Recommendation Proposal

Submittal for November 21, 2016 DRB Meeting

WASHINGTON STATE EMPLOYEES CREDIT UNION (WSECU)
UNIVERSITY DISTRICT

SDCI Project Number: 3022052

5. Materials and Detailing (continued)

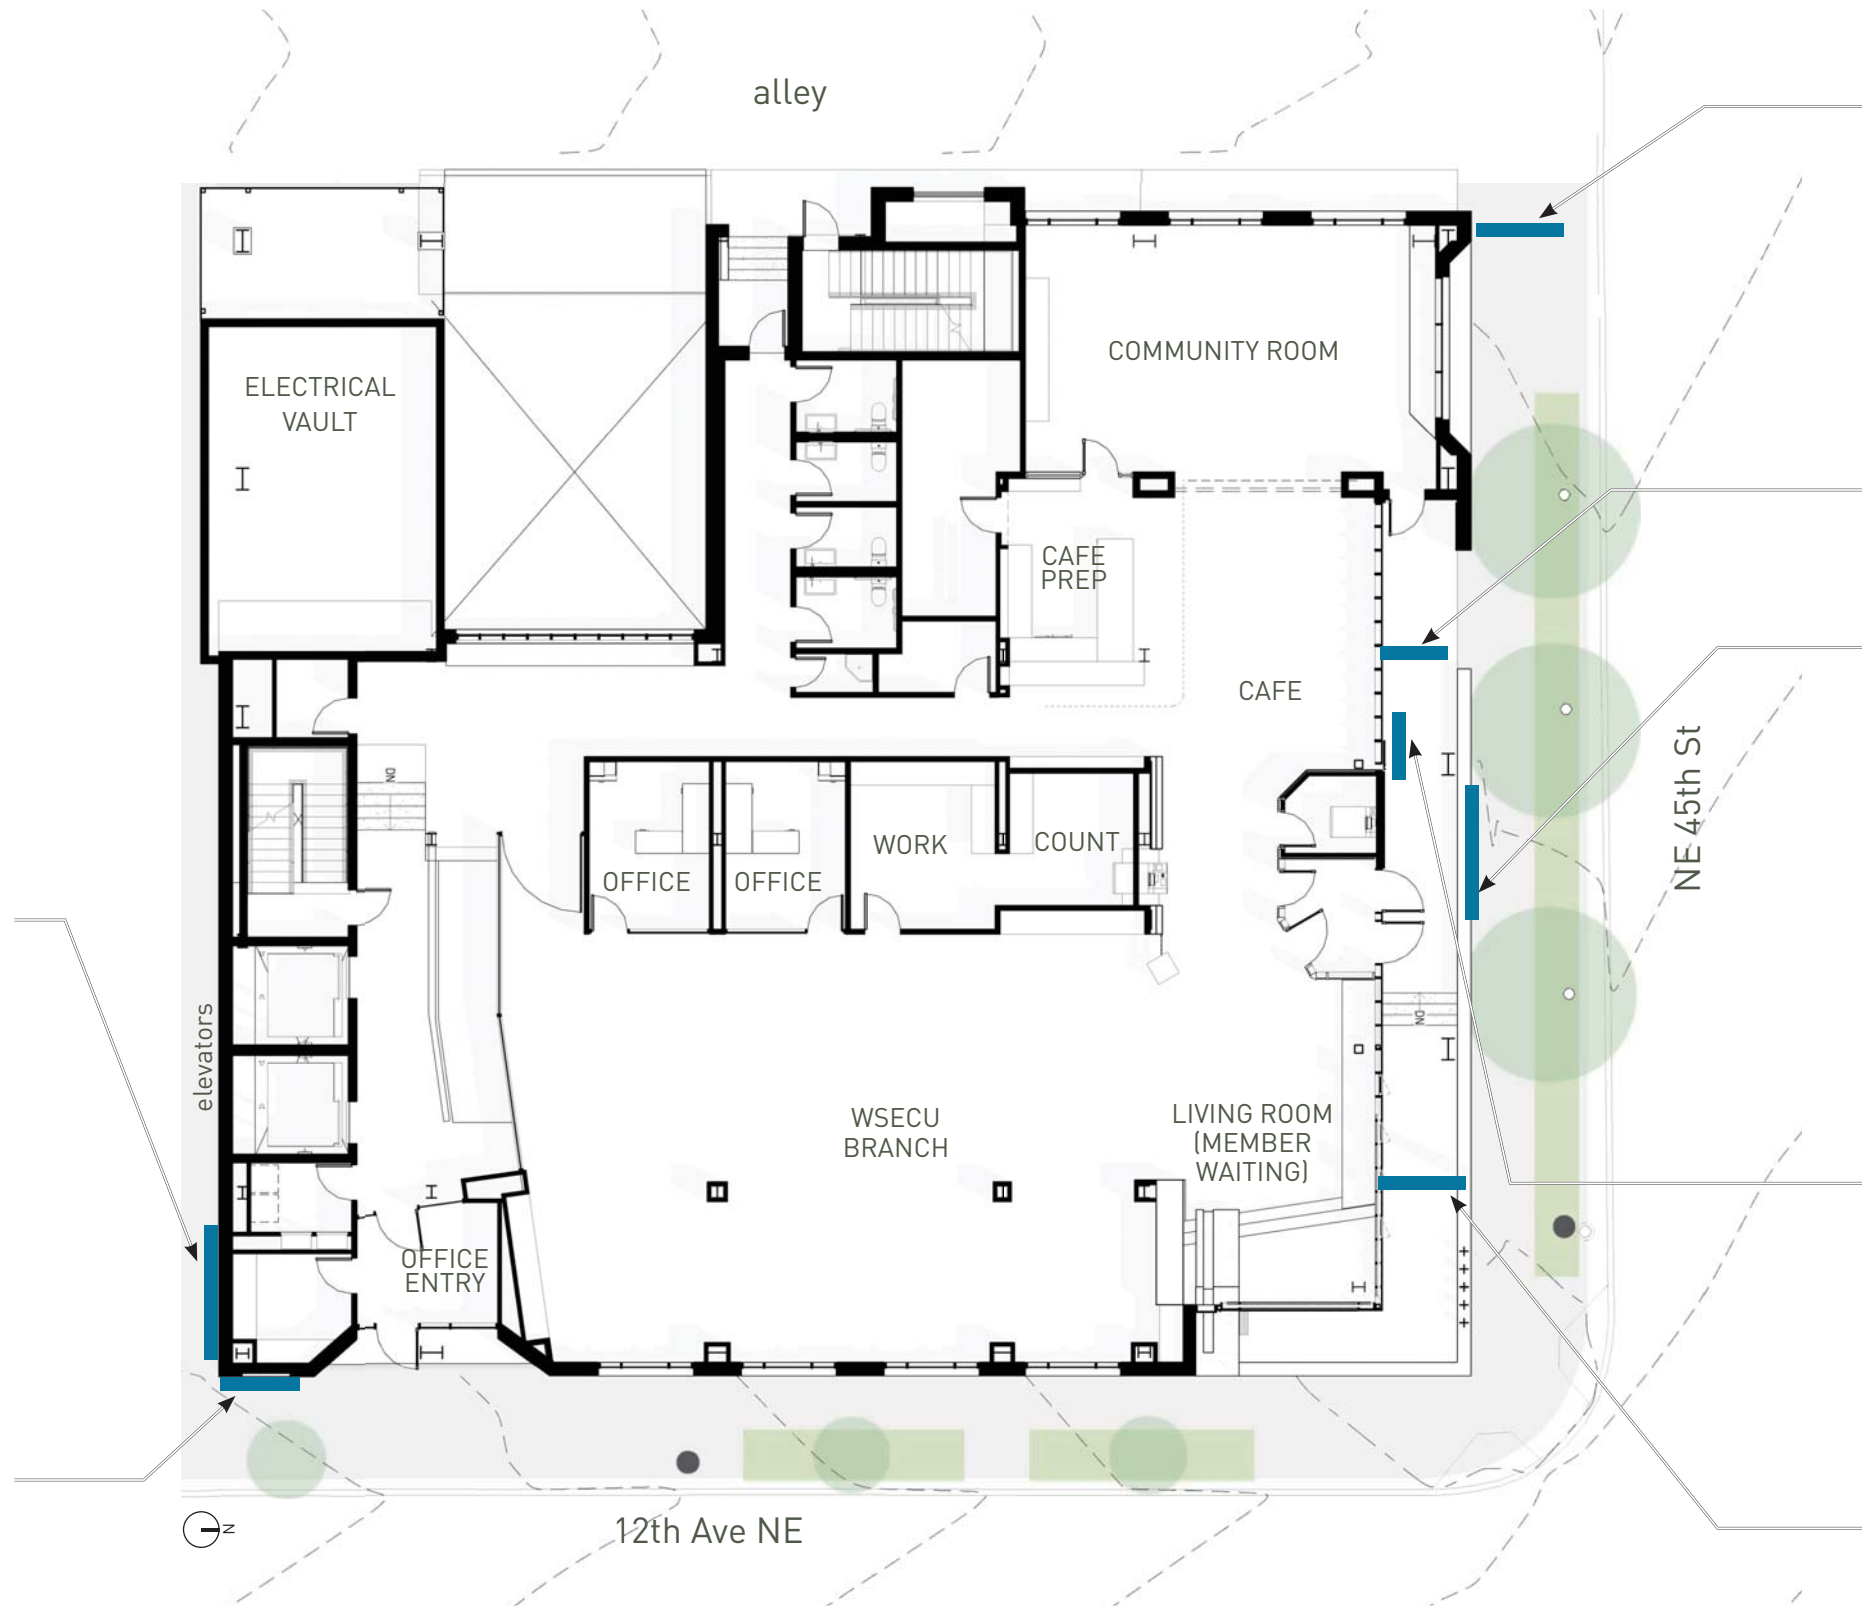
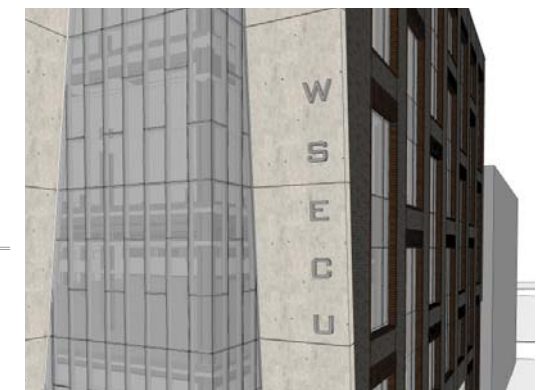
-  **a. Provide brick material as proposed**
 - defines a stately presence which reflects the bank program
(DC2-B, DC2-D, DC4-A)
-  **b. Develop brick detailing**
 - especially important where brick spans the corner opening and where it terminates / meets the sidewalk
(DC2-B, DC2-D, DC4-A)
-  **c. Reinforce/develop the corner expression**
 - retain fluidity of masonry pulled back at corner
 - express the terminus and identify the entry
 - reinforce the contrast between the repetitive glazing mullions and the corner expression
(DC2-B, DC2-D, DC4-A)
-  **d. Coordinate columns, lighting, and signage**
 - complement the project as a whole with coordinated elements
 - provide information about signage
(DC4-B)

The structural columns of the building create a quiet rhythm that allows the colors, textures, and lighting to take prominence. The exterior lighting design complements the building use, while the interior lighting creates a welcoming glow during business hours. Signage is located at strategic points to indicate entry and identity.

a. Detail South facade

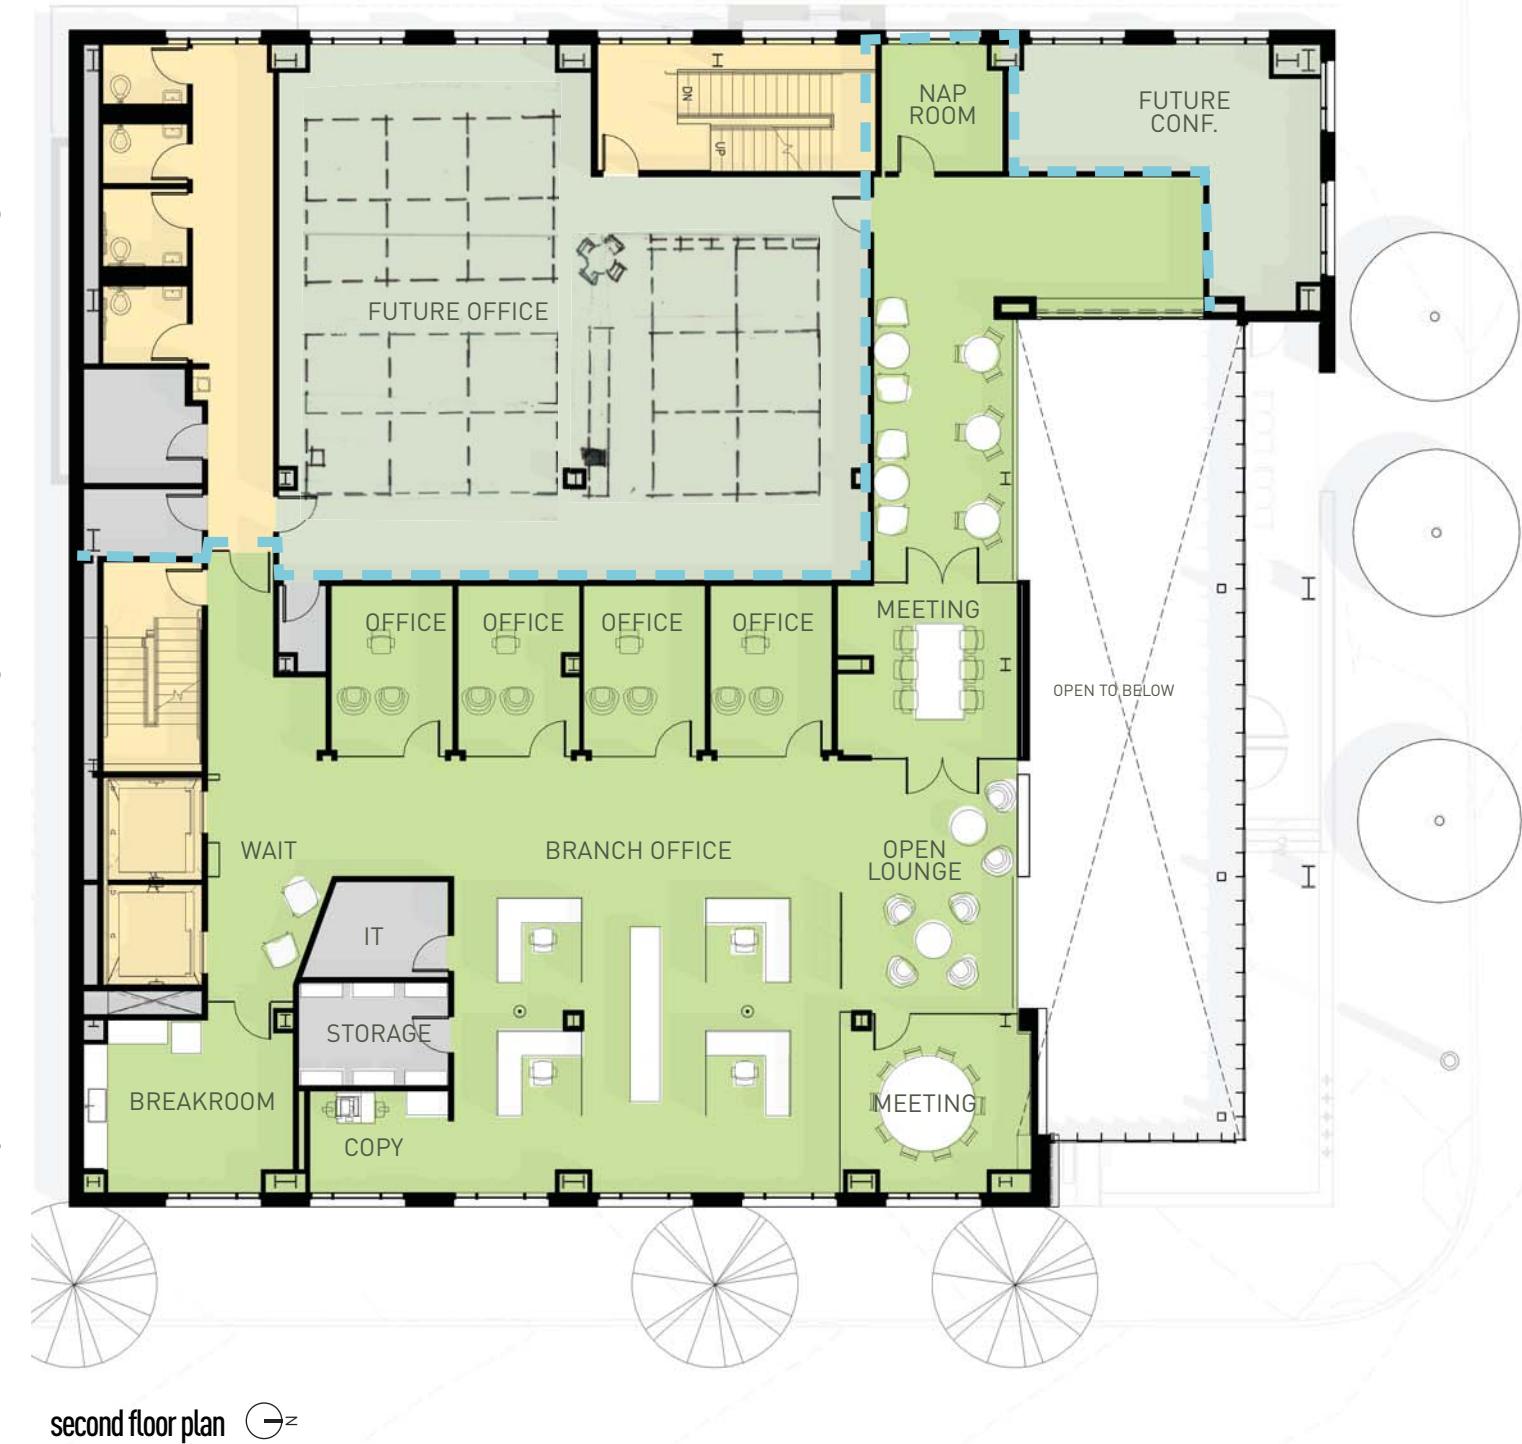
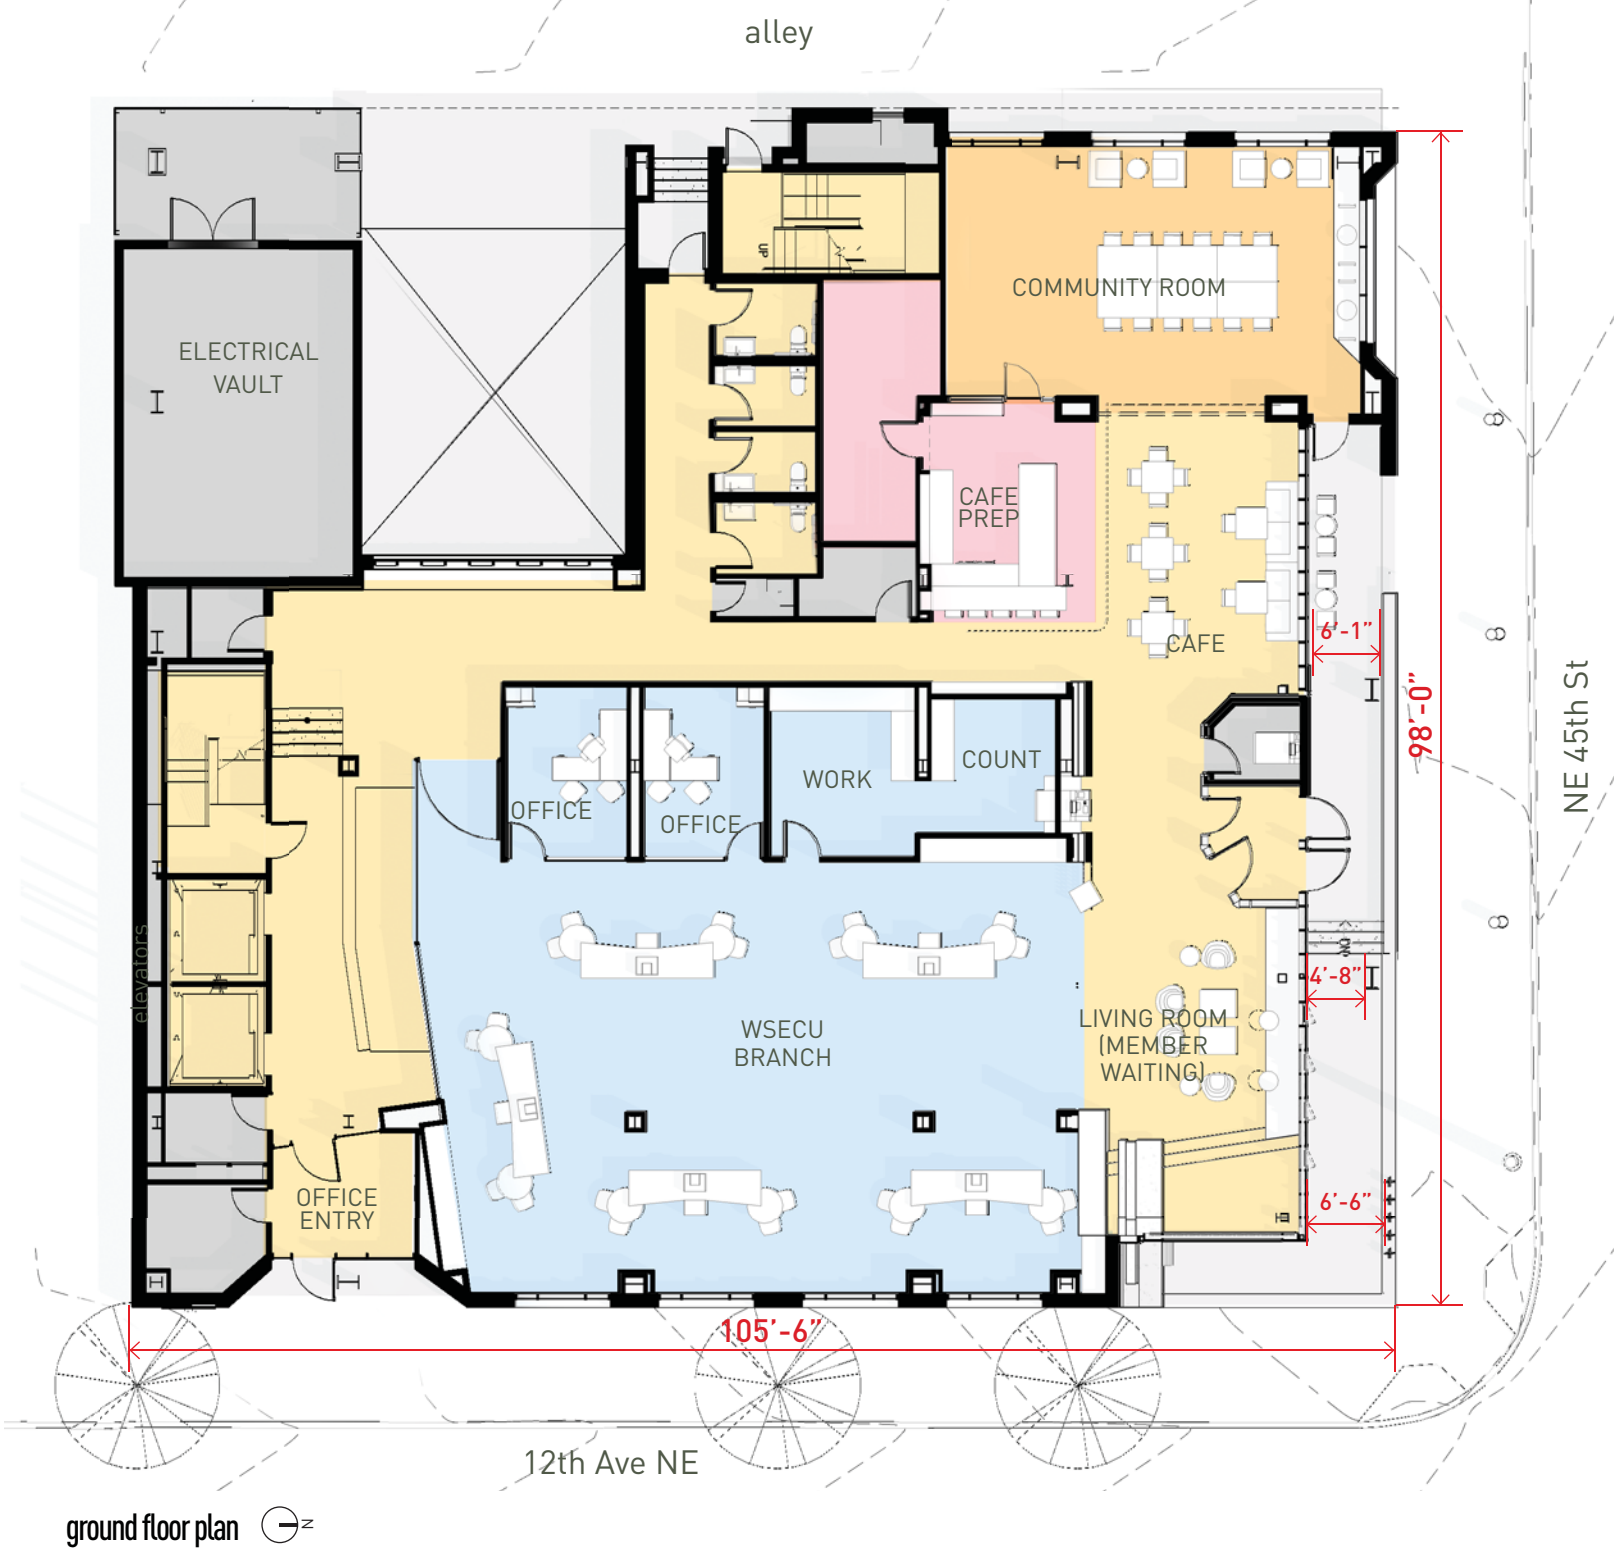
- design and detail all four elevations to the same level
- provide street level perspective views and design intent for the blank wall

The south façade is composed with the field brick of the main facades returning at the corners and the parapet to complete the “box” and create a “frame” for the inset field material. The inset is a darker-than-standard ground-faced CMU. This is in keeping with a more traditional party wall material application, but with a slightly more refined approach. In addition, the upper right portion of the South wall will be painted such that the contrast against the block will create an identifying “WSECU” sign. This sign will be visible when traveling North on 12th Ave, until future development of the adjacent building covers this wall. This party-wall painted sign treatment is very common on old brick buildings throughout Seattle and the U-District.
